UNITED STATES
NUCLEAR REGULATORY COMMISSION
REGION III
727 ROOSEVELT ROAD
GLEN ELLYN, ILLINOIS 60137

MEMORANDUM FOR: Ray Sutphin, Reactor Inspector
FROM: E. J. Gallagher, Reactor Inspector
SUBJECT: INPUT FOR SALP APPRAISAL ON MIDLAND 1 AND 2

MEMORANDUM FOR: H. D. Thornburg, Director, Division of Reactor
Construction Inspection, IE
FROM: James G. Keppler, Director
SUBJECT: MIDLAND SUMMARY REPORT

Residual settlement of the sand layer

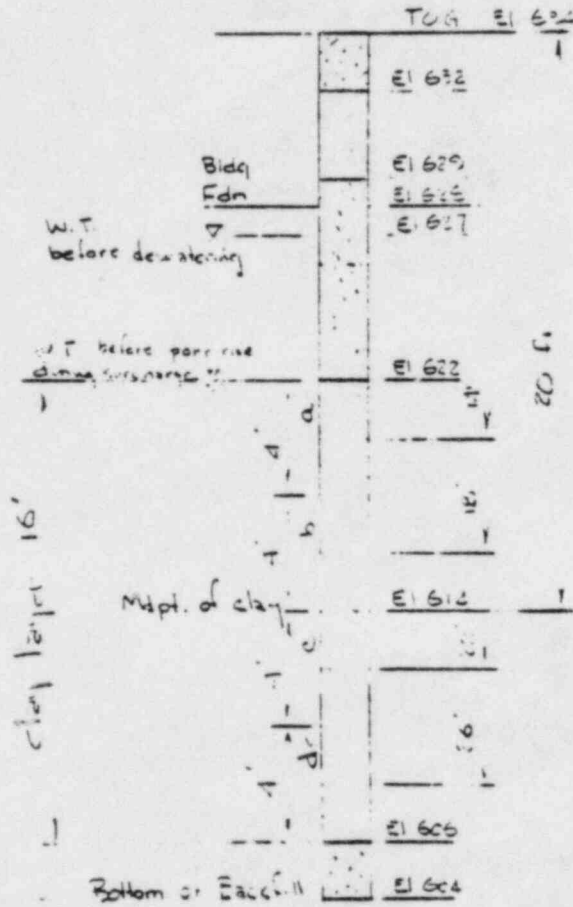
The simplified consolidation analysis of the clay layer indicates that measured settlements are within the range of calculated settlement for the surcharge loading. This consolidation analysis indicates that future settlements of the clay layer would be due to secondary compression and not to additional consolidation of the clay.

The time-related settlement of the upper sand layer would be about $\frac{1}{2}$ inch over the life of the project. This type of settlement in sand is comparable to secondary compression within clay. This is the only settlement not previously computed, and does not appear in the response.

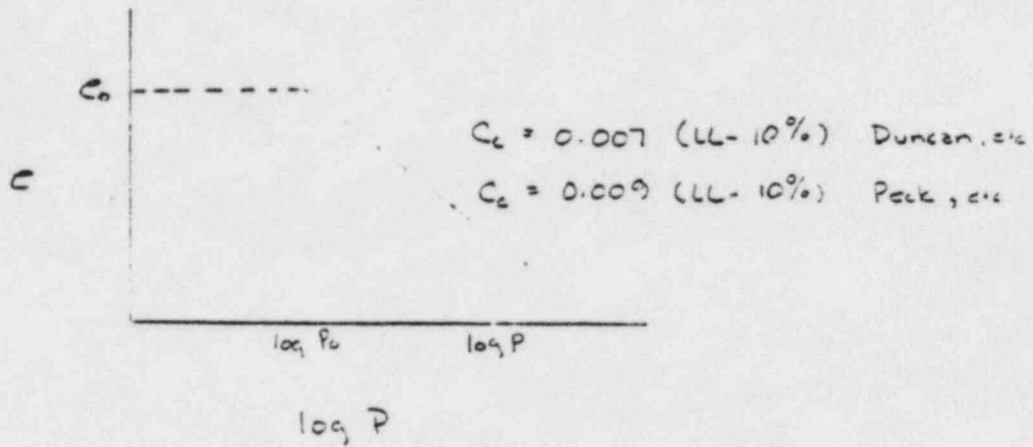
$$S = \frac{5p - C_e}{(11.5) C_b A} \quad (\text{Meyerhoff Equation})$$

where p = stress below footing = 45 ksf = 225 tons/ft²
 N = average clay count = 12
 C_b = correction factor for depth of influence = 0.95
 C_e = time rate factor (40 years) = 1.5
 A = averaging factor = 3

$$S = \frac{5(225) 1.5}{(11.5) 0.95(3)} = 0.56 \text{ inches}$$

Meyerhoff's equation predicts settlements which vary from 0.9 times to 1.1 times the actual settlement - averaging factor to compensate for this.

Residual settlement of the sand layer.

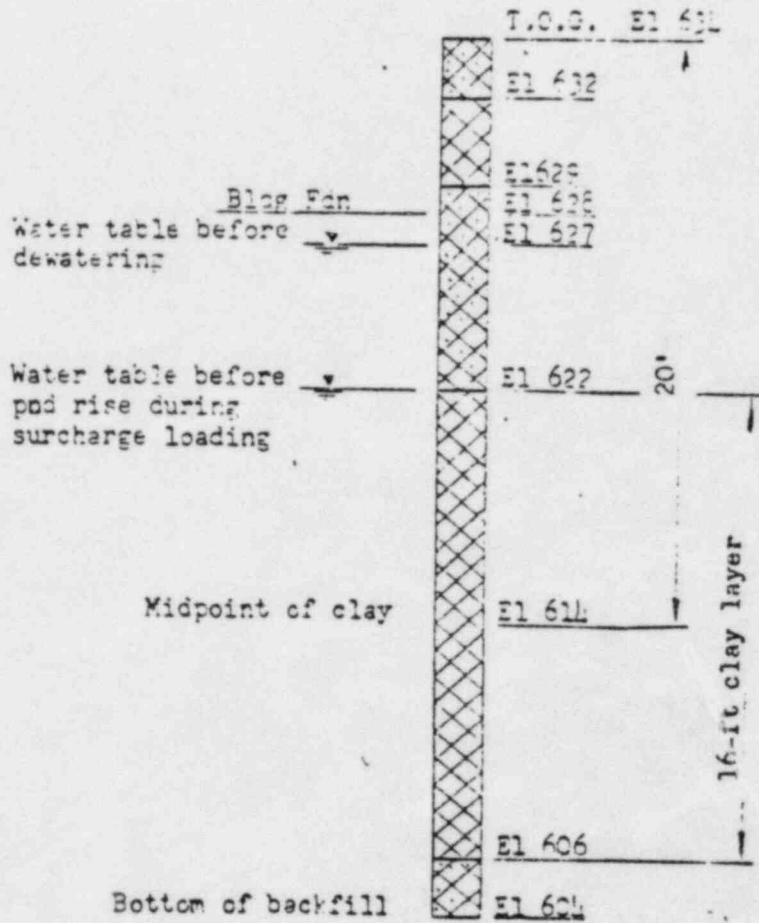
The simplified consolidation analysis of the clay layer indicates that measured settlements are within the range of calculated settlement for the surcharge loading. This consolidation analysis indicates that future settlements of the clay layer would be due to secondary compression and not to additional consolidation of the clay.

The time-related settlement of the upper sand layer would be about 1/2 inch over the life of the project. This type of settlement in sand is comparable to secondary compression within clay. This is the only settlement not previously computed, and does not appear in the response.

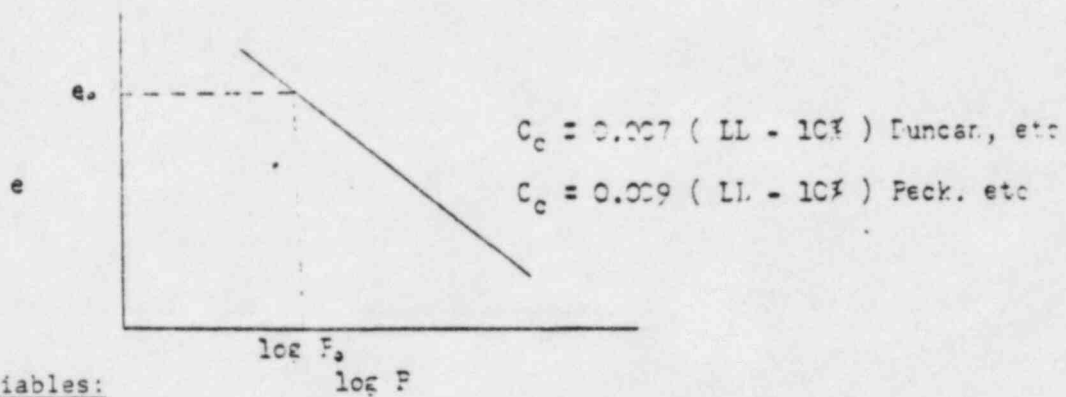
C_t = time rate factor (40 years) = 1.5

$$S = \frac{5 (2.25) 1.5}{(12-1.5) 0.95 (3)} = 0.56 \text{ inches}$$

Meyerhoff's equation predicts settlements which vary from 0.9 times to 7 times the actual settlement - averaging factor to compensate for this.

Fig. 4.17 Influence diagram for vertical normal stress σ_z at various points within an elastic half-space under a uniformly loaded circular area. (After Foster and Ahlvin, 1954.)

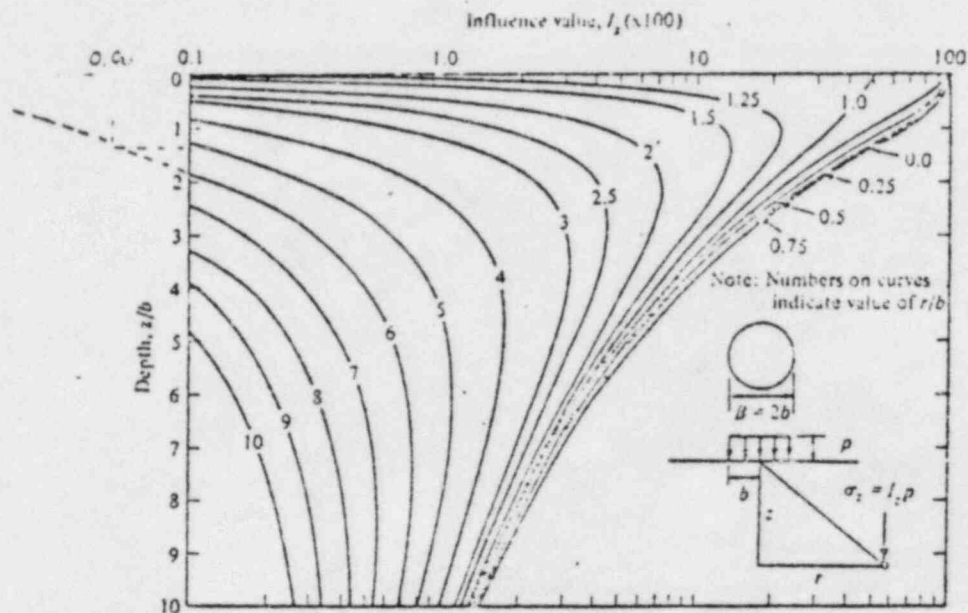
(2) Influence of Second Tank. The influence factor of the loading of one tank on the other is shown by the following diagram.

$$\begin{aligned} B &= 2b = 52 \text{ feet} & b &= 26 \text{ feet} \\ Z &= 35 \text{ (maximum depth)} \\ Z/b &= 1.35 \\ r &= 26 + 130 = 156 \\ &\text{(center of one tank to side of the other)} \\ r/b &= 6.0 \end{aligned}$$

From diagram, $I_z = 0.0006$
